*ARM FRAME DETAIL (SIDE VIEW)

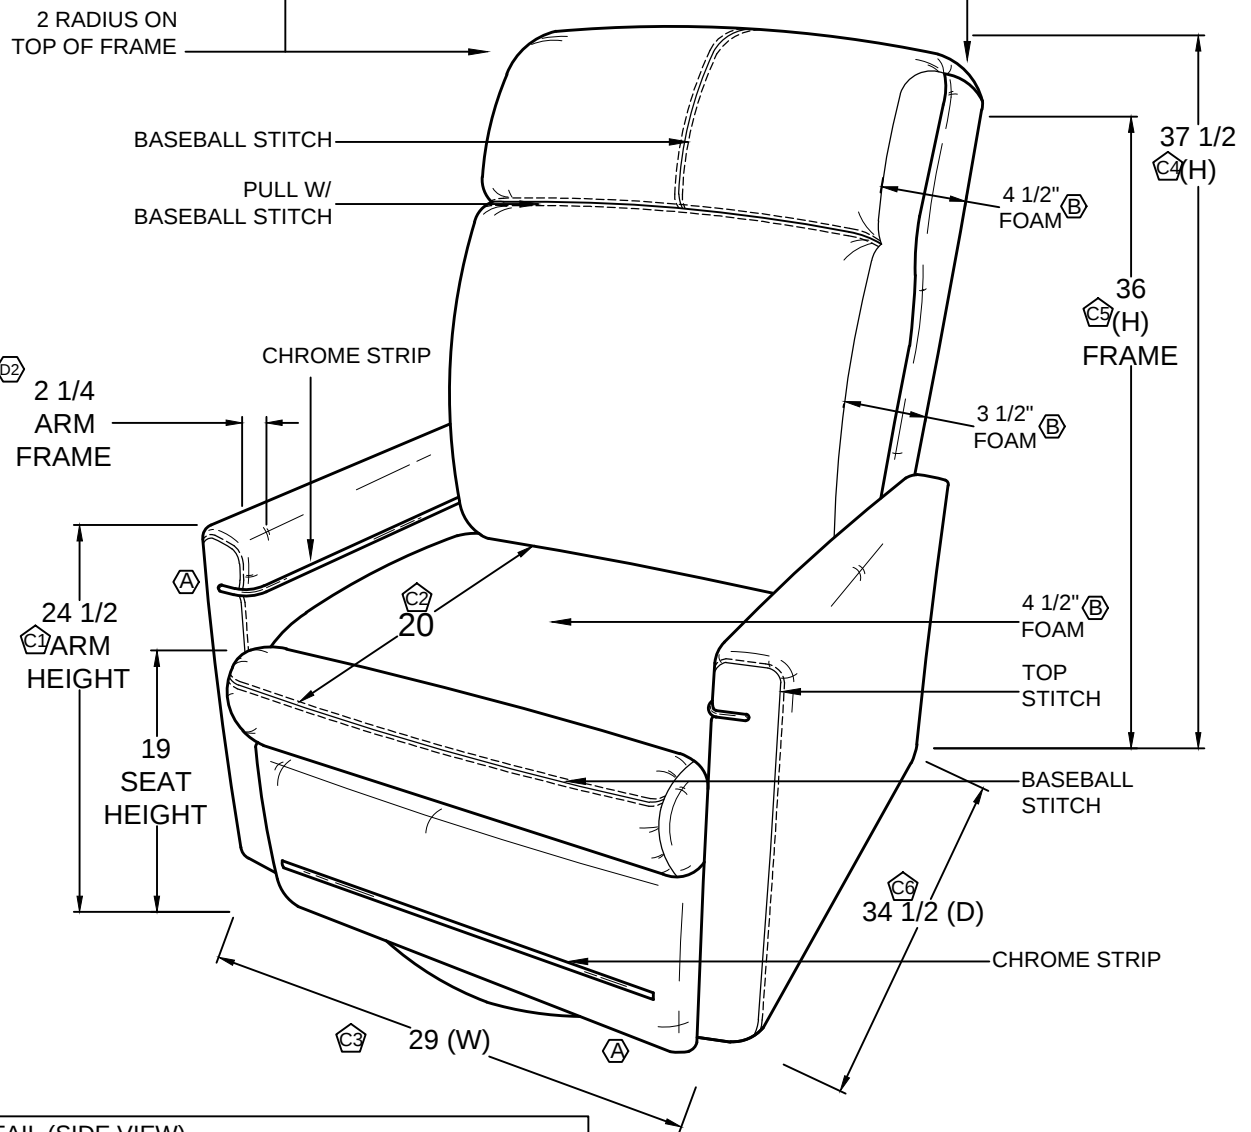
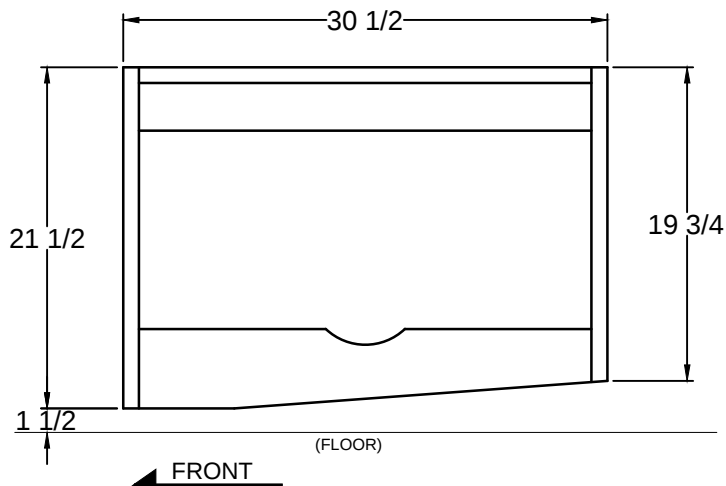
JA	D	PRODUCTION UPDATE: [1] ADD ARM FRAME DETAIL. [2] CHANGE ARM FRAME WIDTH TO 2-1/4"; WAS 2".	01.29.19
FP	C	PER RL: [3] ADJUSTED ARM HEIGHT TO 24 1/2" WAS 21"; [2] ADDED DIMENSION OF 20"; [3] ADJUSTED WIDTH TO 28 1/2" WAS 29"; [4] ADJUSTED G.A. HEIGHT TO 37 1/2" WAS 40 1/2"; [5] ADJUSTED FRAME HEIGHT TO 36" WAS 38"; [6] ADJUSTED DEPTH TO 34 1/2" WAS 36 1/2"	01.02.19
AC	B	PRODUCTION UPDATE: ADDED FOAM INFORMATION.	03.27.18
JA	A	PER RL, CHROME STRIP ADJUSTMENTS.	03.21.18
